ADDENDUM NO. 1

**HARDY SCHOOL PLAYGROUND RENOVATION
Arlington, MA**

Bid No. 21-04

January 29, 2021

Drawing Title:
ADD ALTERNATE #2 DRAINAGE PLAN

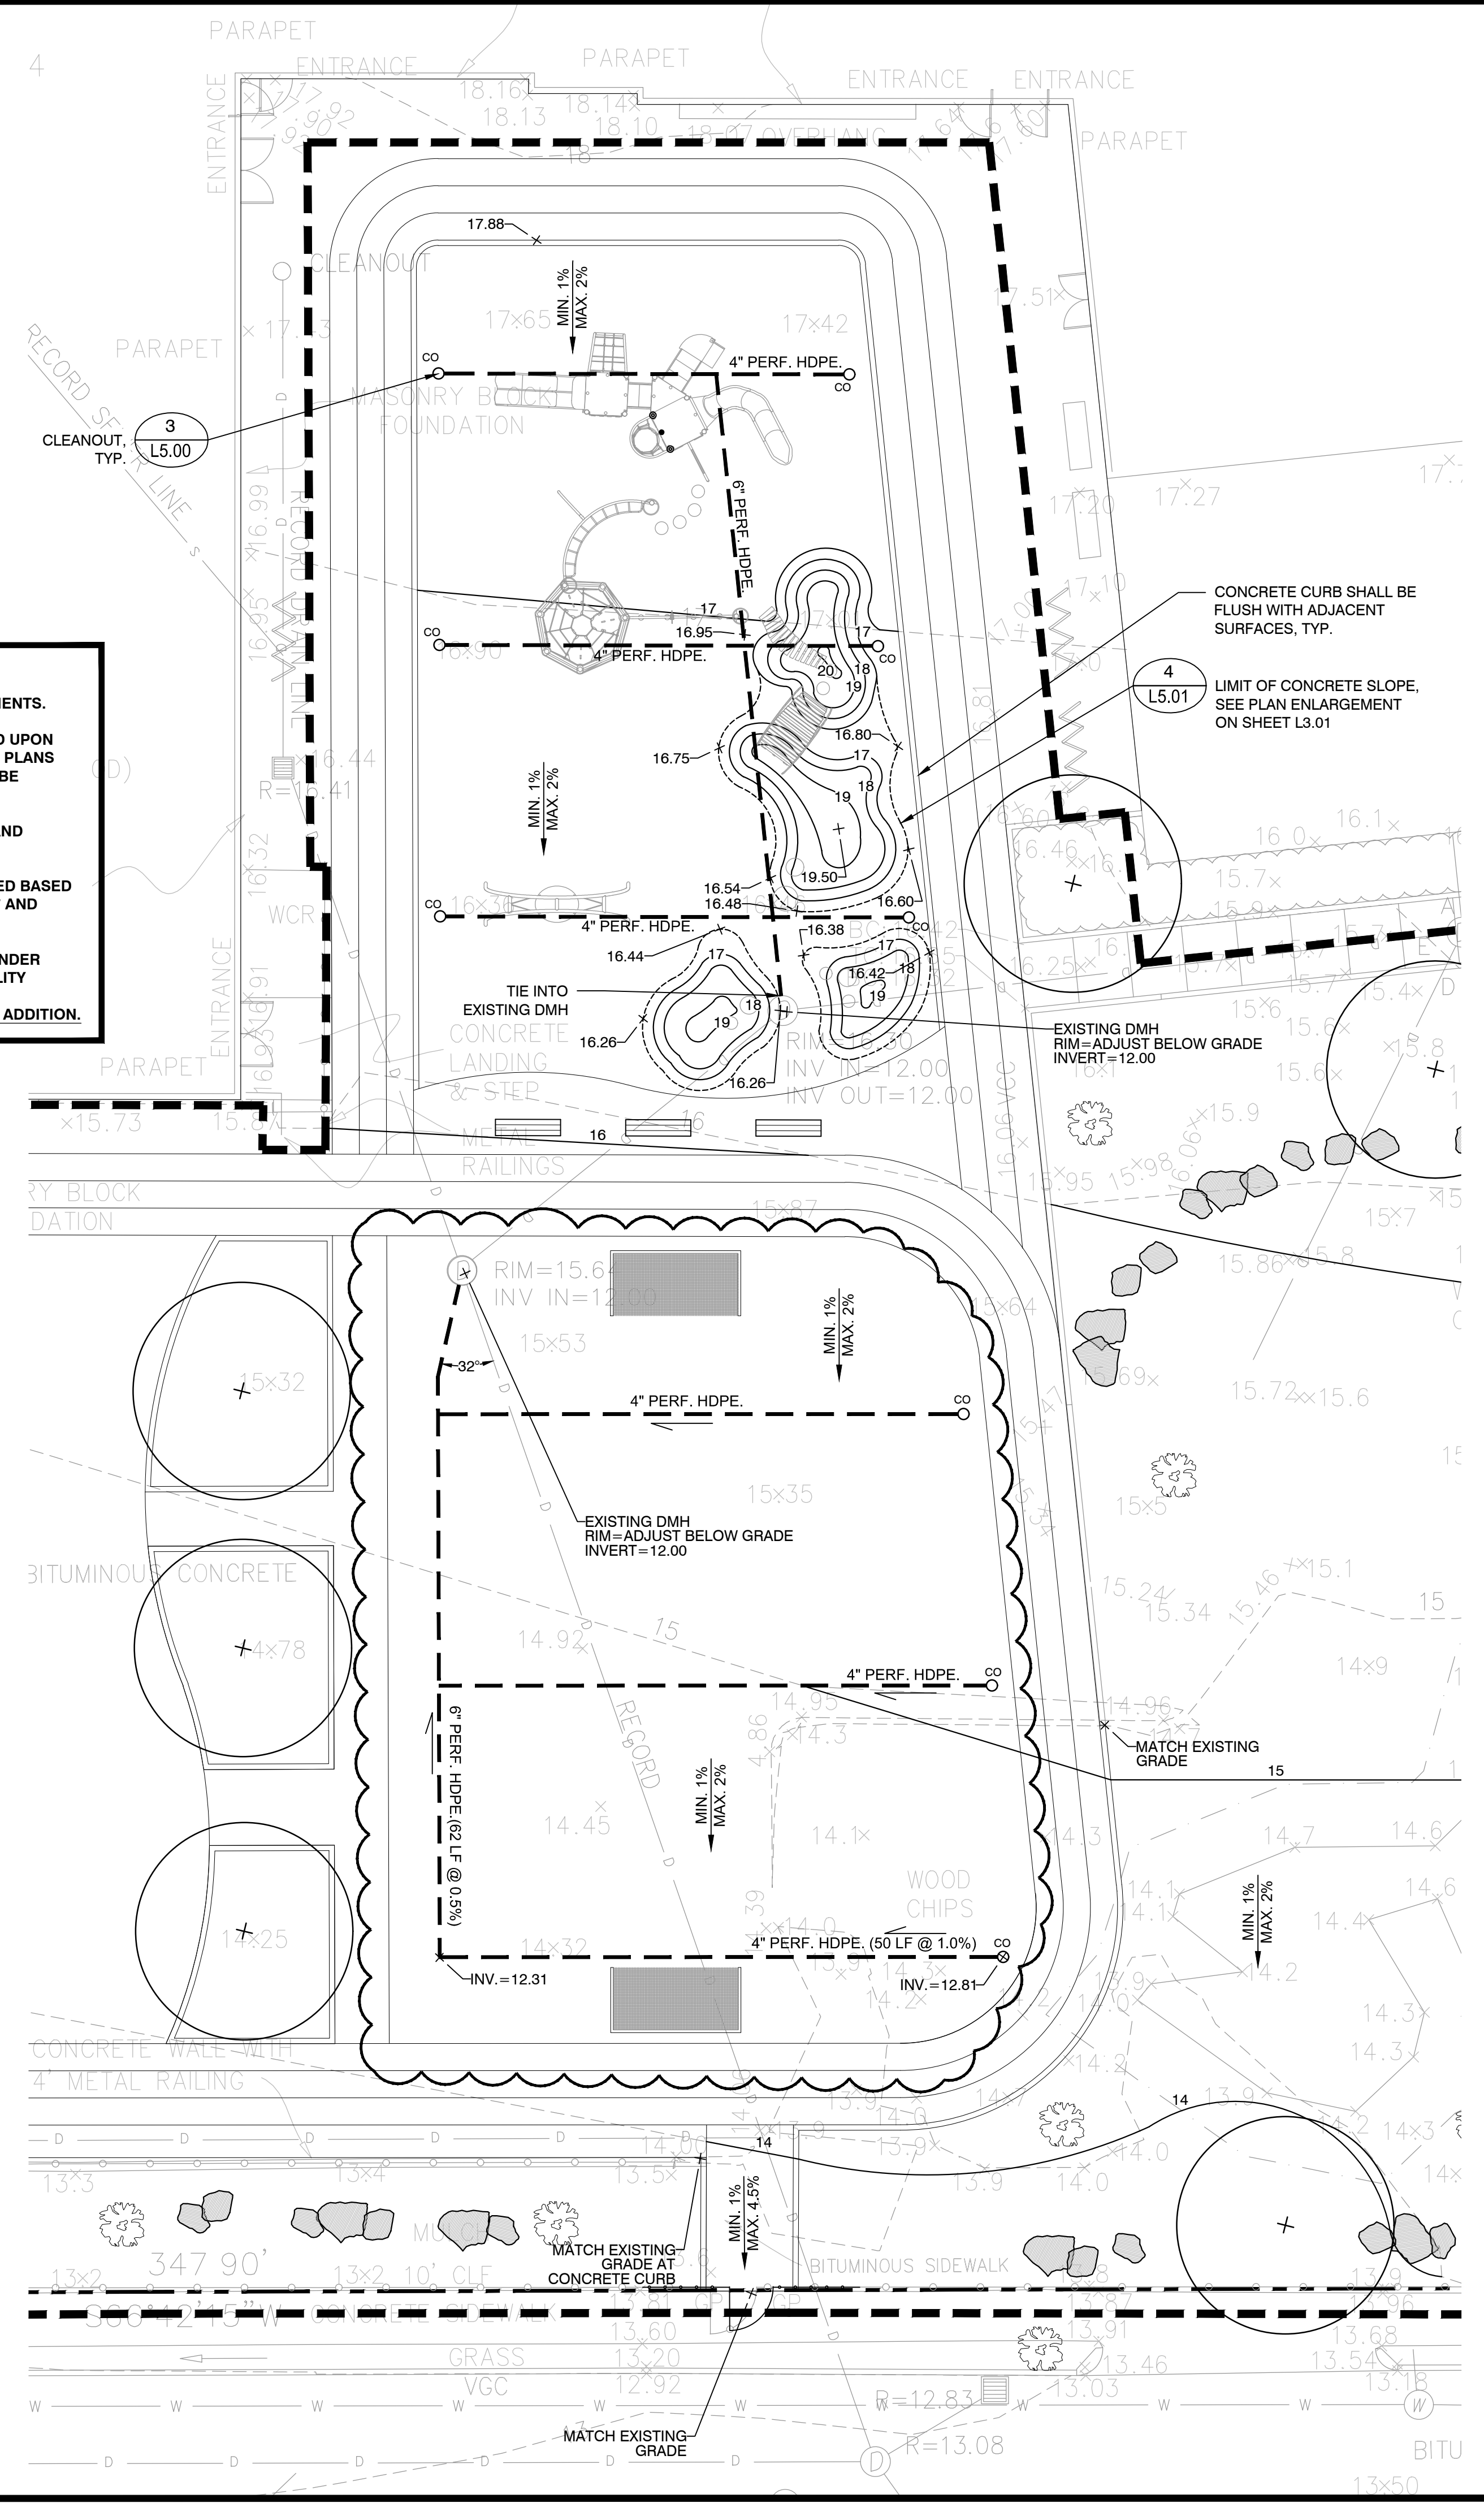
Question 11: Please clarify if any underdrainage is needed for alternate #1.

Answer: Please see SK-2 for the underdrainage included in the add alternate.

POURED-IN-PLACE RUBBER SAFETY SURFACING COLOR CHART

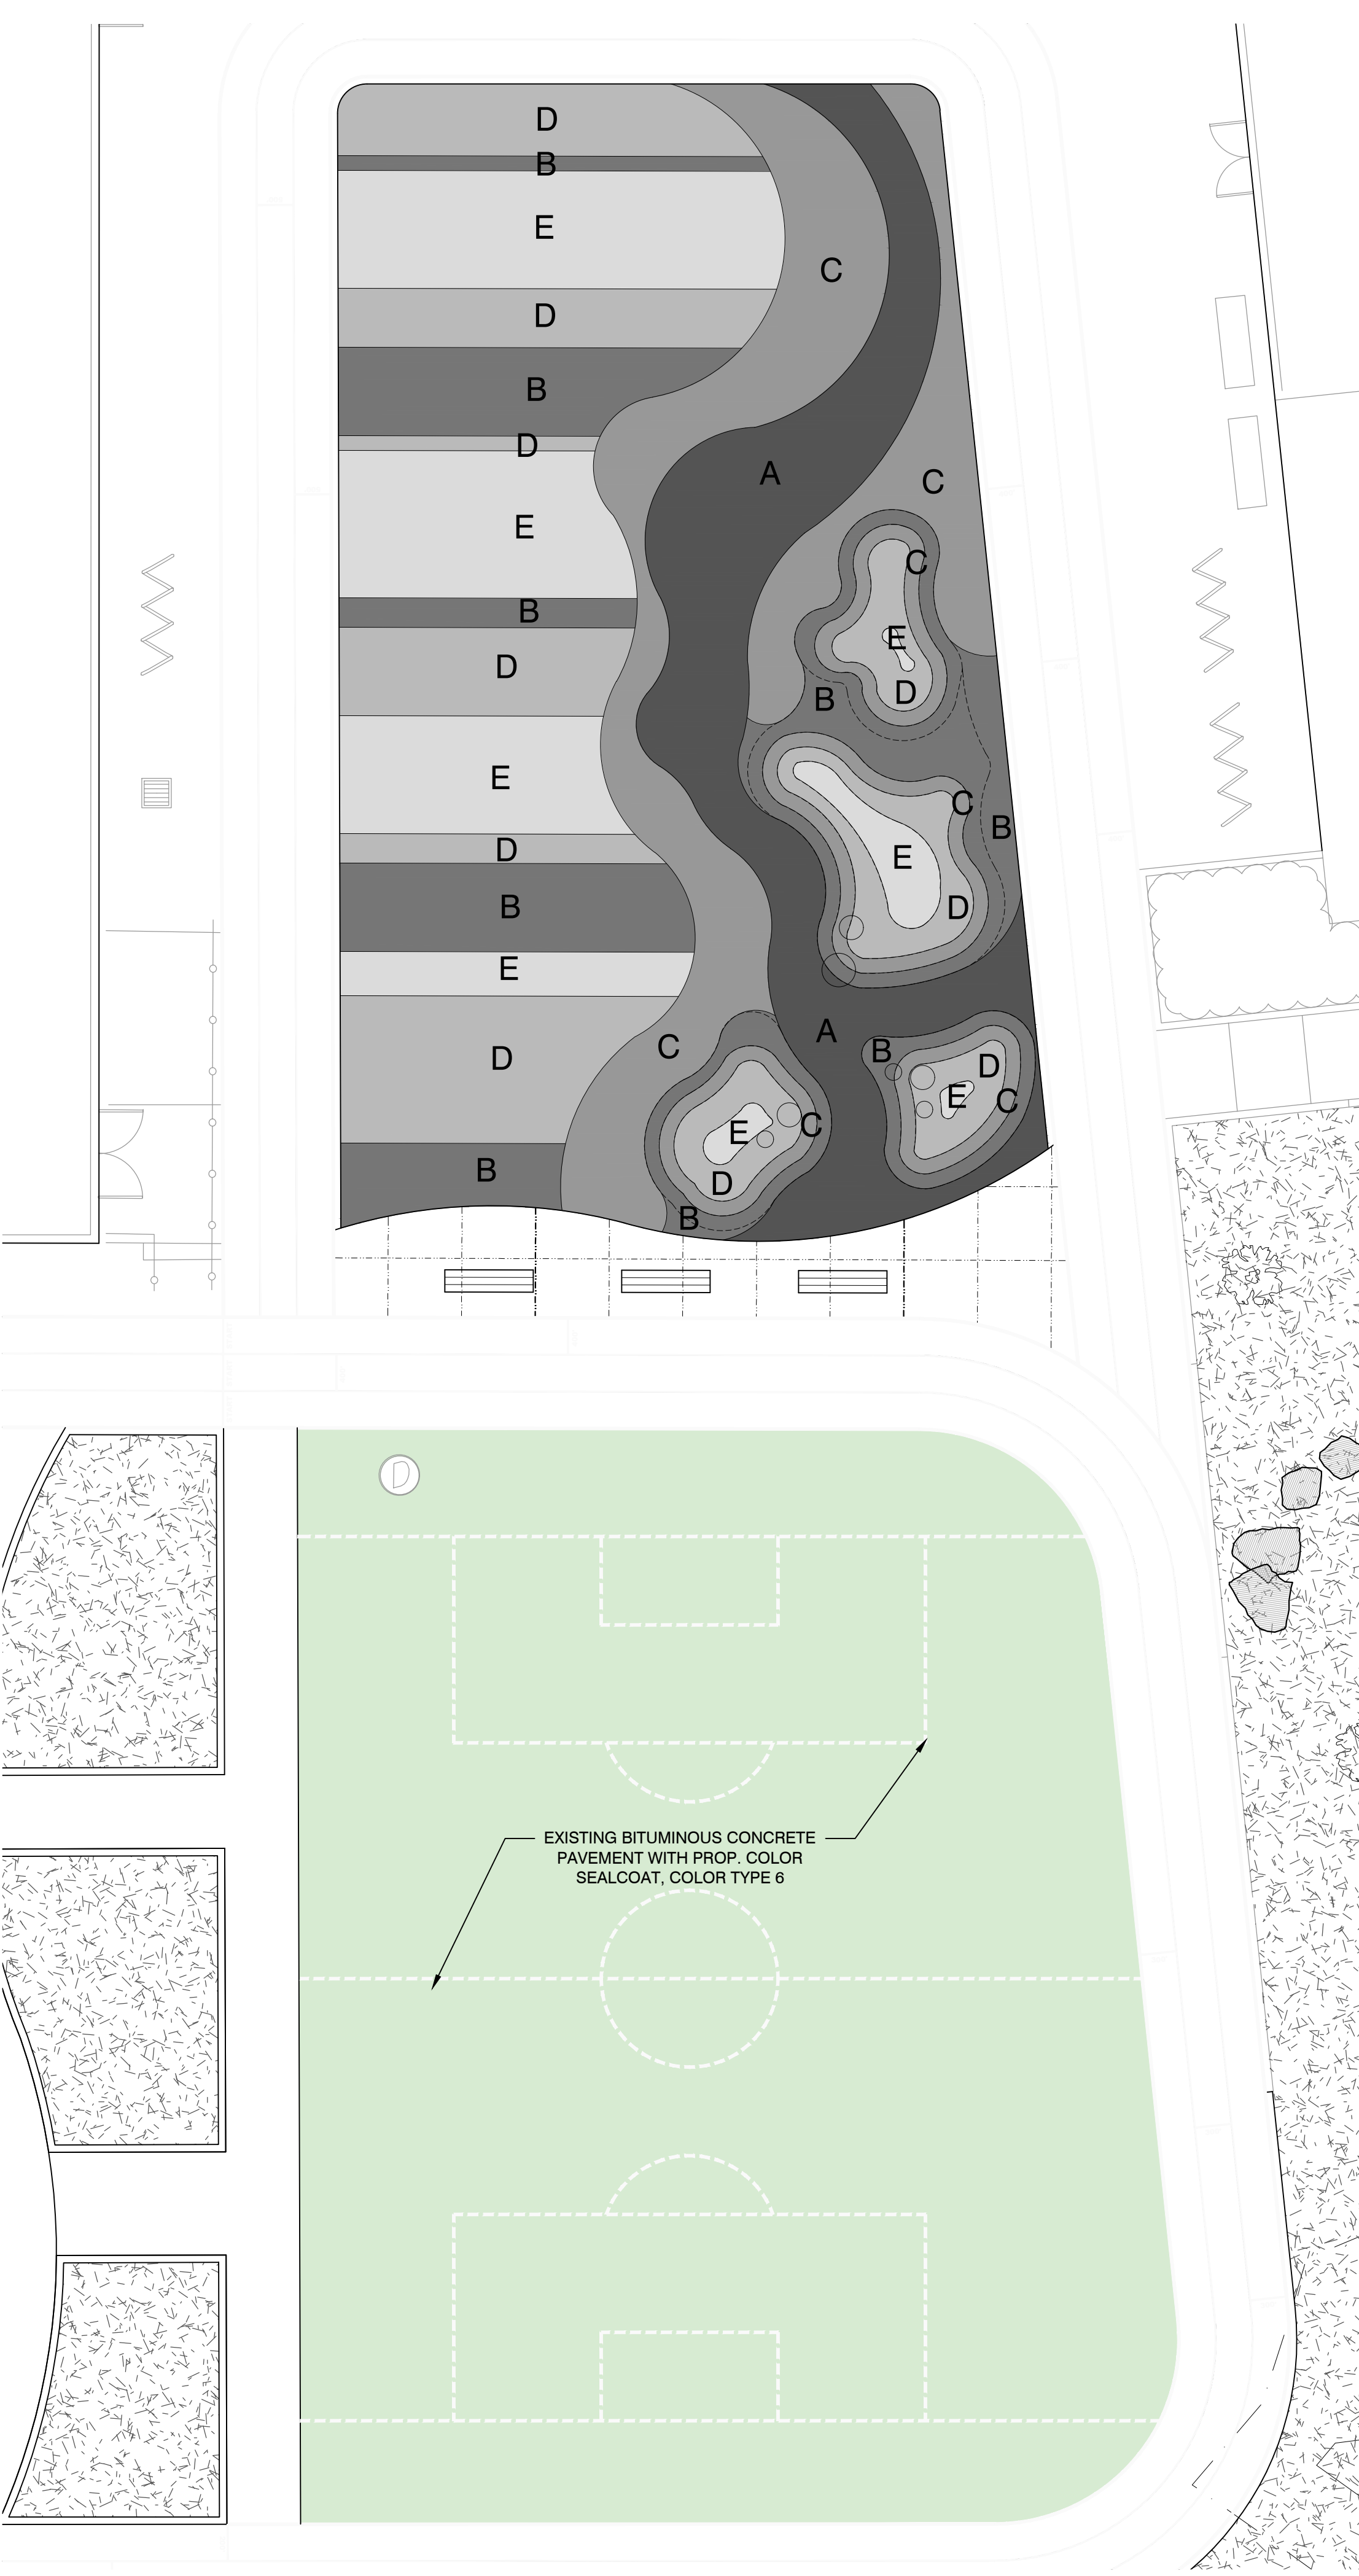
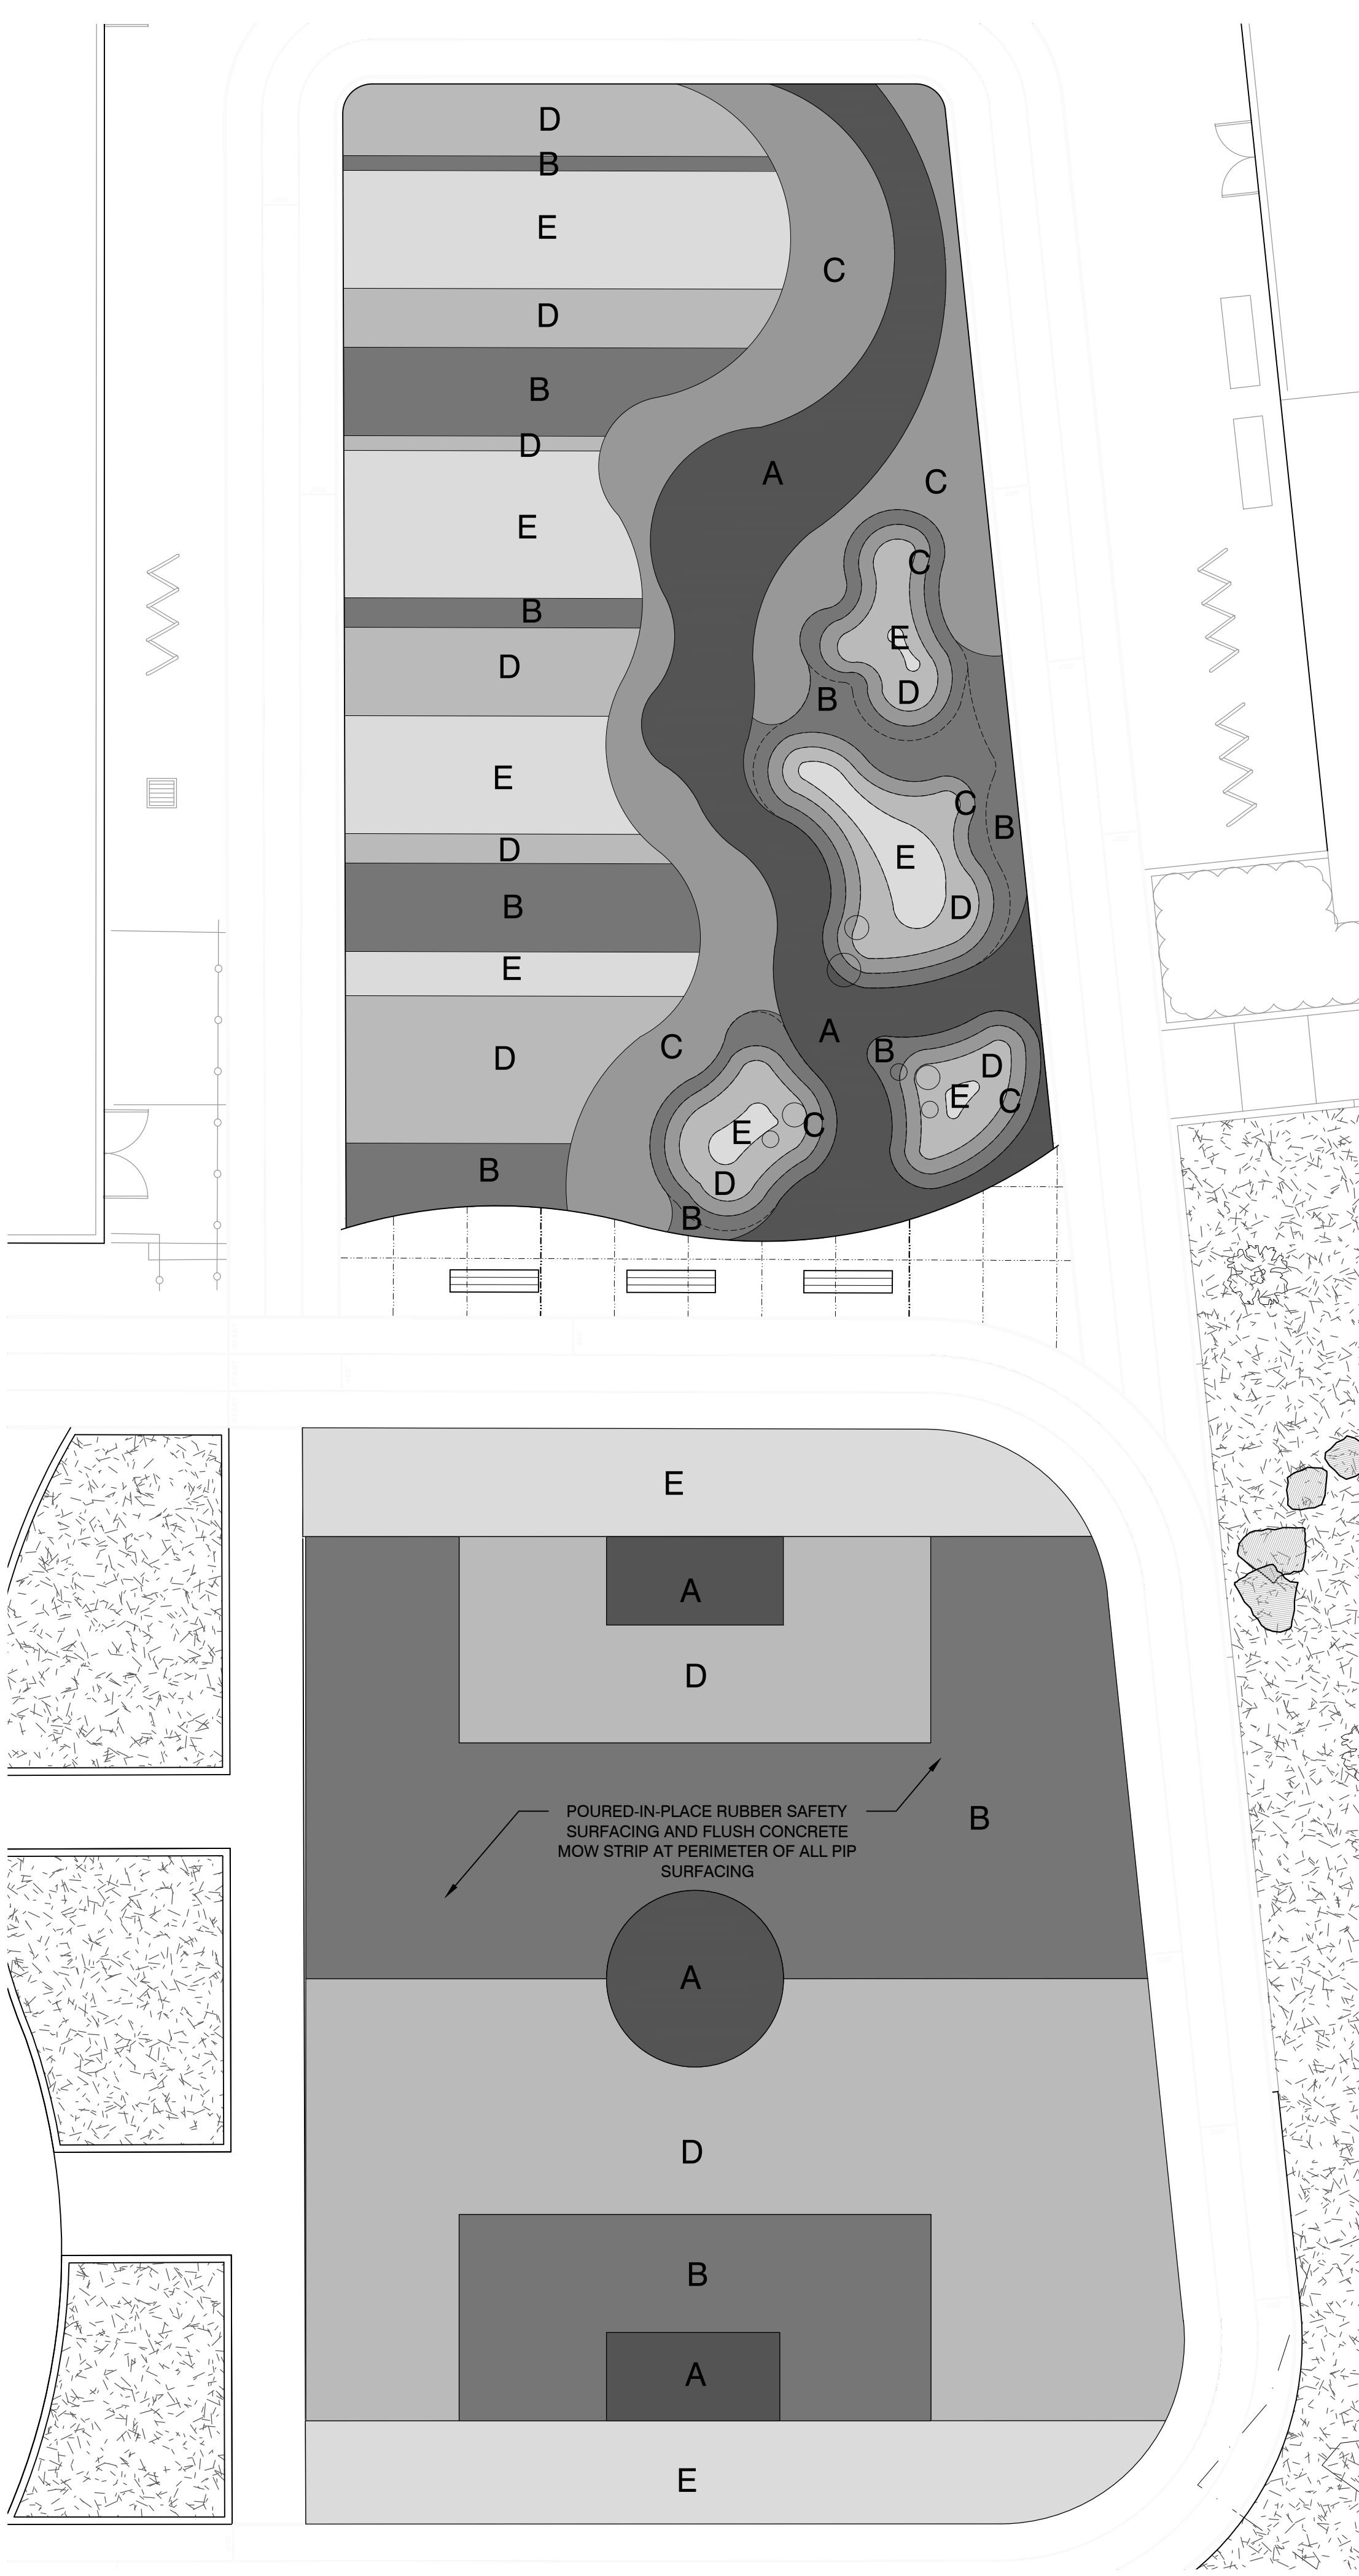
Question 6: Does the PIP surfacing in alt #1 need to depict the soccer field lines?

Question 7: Please confirm what color or color combinations the PIP surfacing shall be for alt #1.

Answer: Refer to SK-4 for a revised poured-in-place safety surfacing color layout and pattern..

Answer: The colors of the poured-in-place rubber safety surfacing shall be determined during the submittal process, as noted in the specifications. Refer to SK-4 for a revised poured-in-place safety surfacing color layout and pattern..
